Origination Form
Proposed Revisions to a Standard Plans Index

Originator:	Turley, Joshua	Index Number:	455-060
Date:	5/15/2025	Sheet Number(s):	Sheet 1
E-mail:	Joshua.Turley@dot.state.fl.us	Index Title:	60" PRESTRESSED CONCRETE CYLINDER PILE

ELEVATION

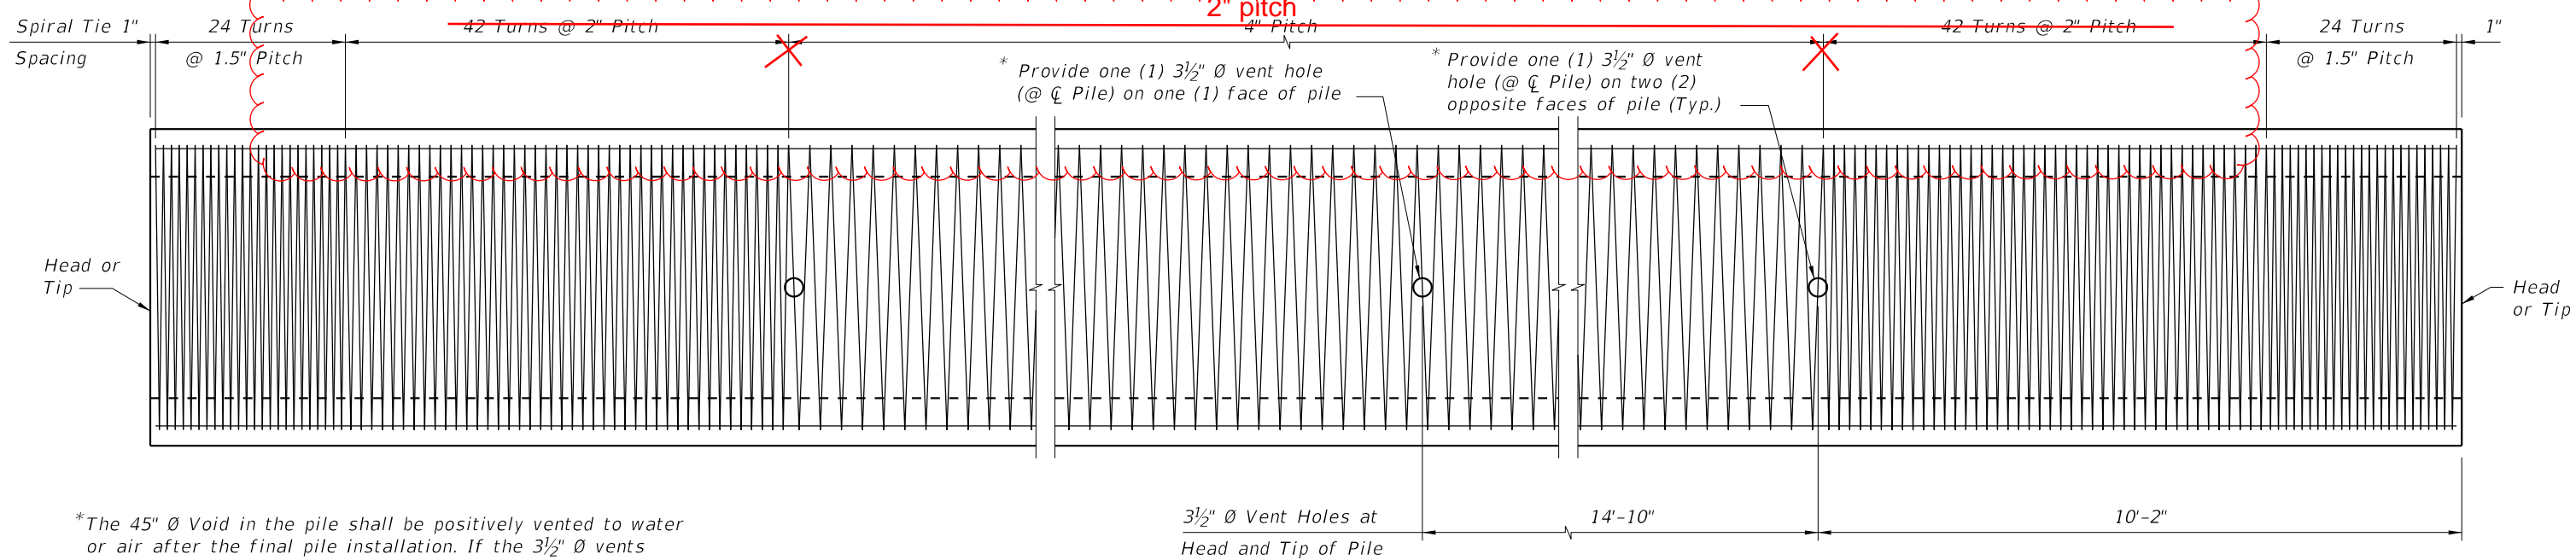
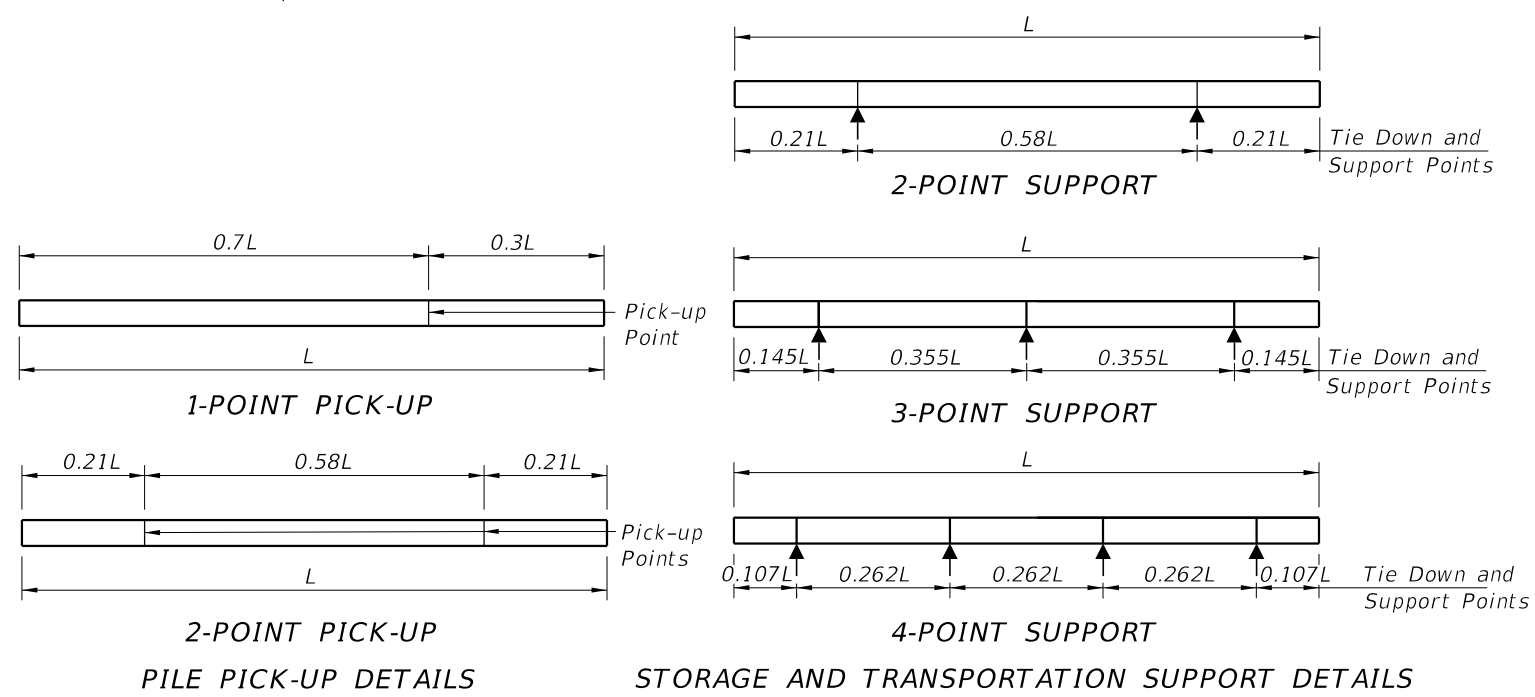
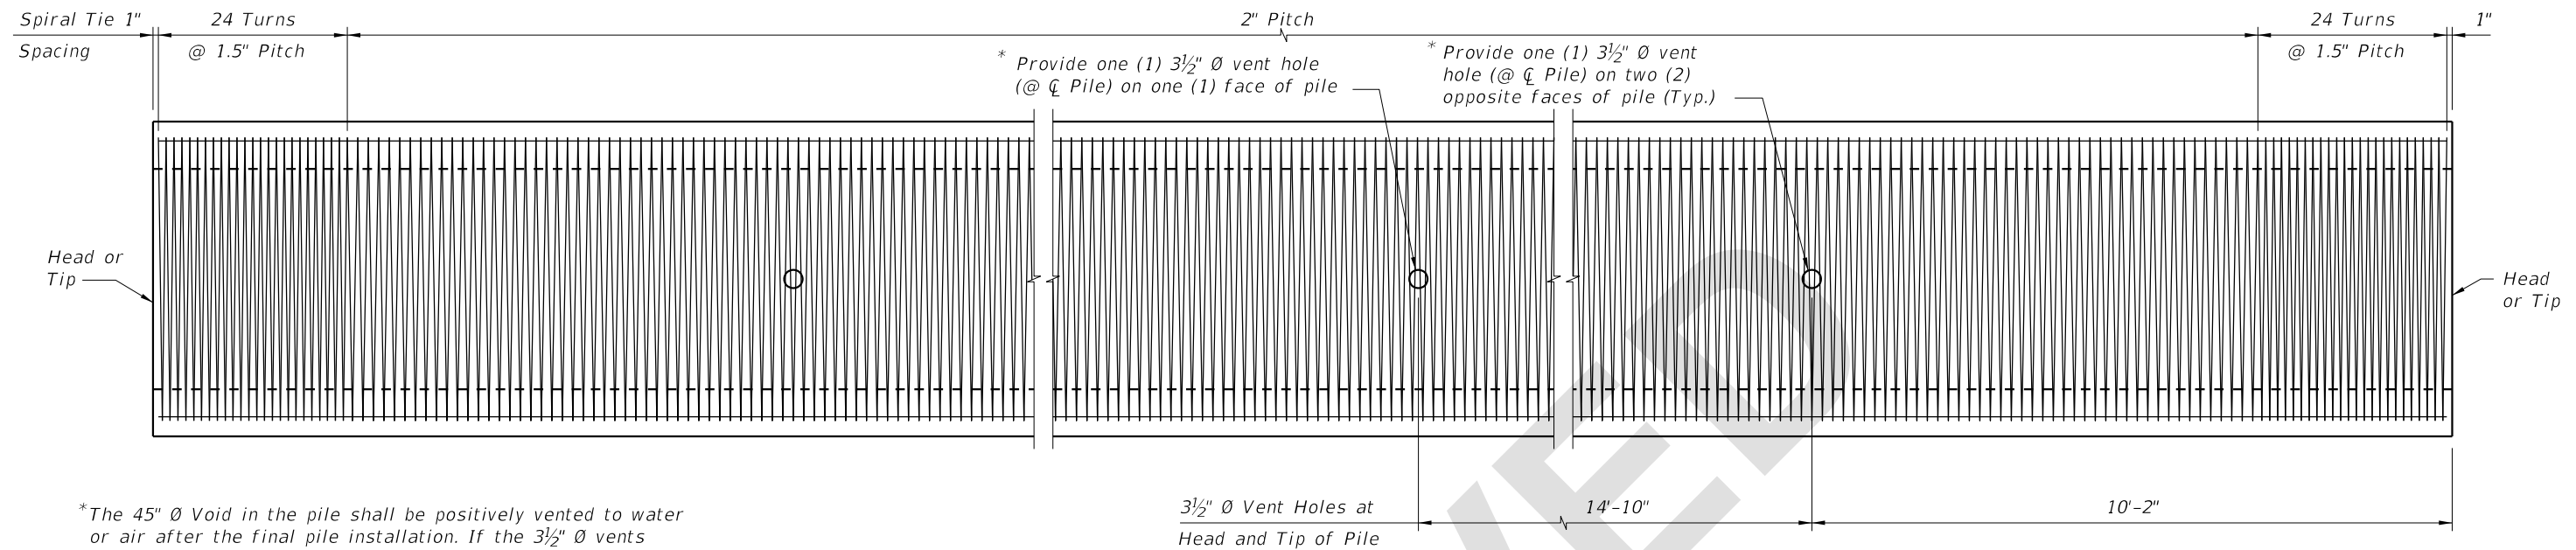
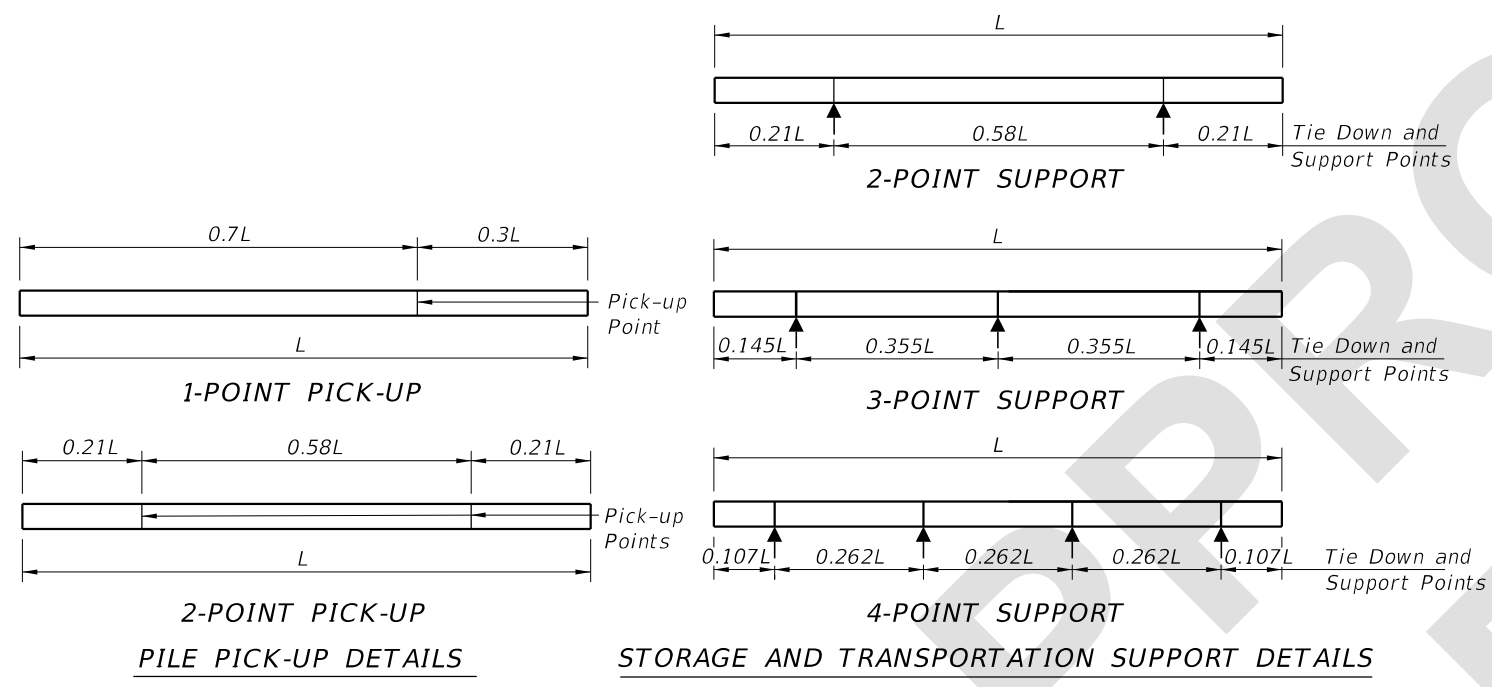
Sheet 1: Changed the pitch spacing of the stirrups in the ELEVATION.

Vertical cracking has been observed in hollow core prestressed concrete piles, including 30-in. voided square HMC and conventional piles, and 60-in. hollow cylindrical piles, during installation and service. To address cracks frequently occur within the 4" stirrup pitch zone, a reduction in stirrup pitch to 2" is proposed to help mitigate cracking in these areas.
